# PHASE 1 PROPERTY INSPECTION REPORT

### ITEMS IN NEED OF REPAIR BEFORE POURING THE CONCRETE

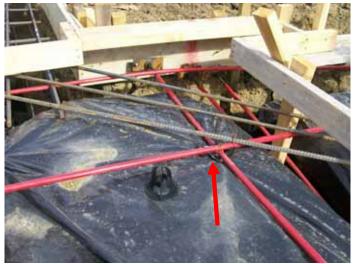
Cable ends need to be wrapped. Plumbing lines need to be insulated.
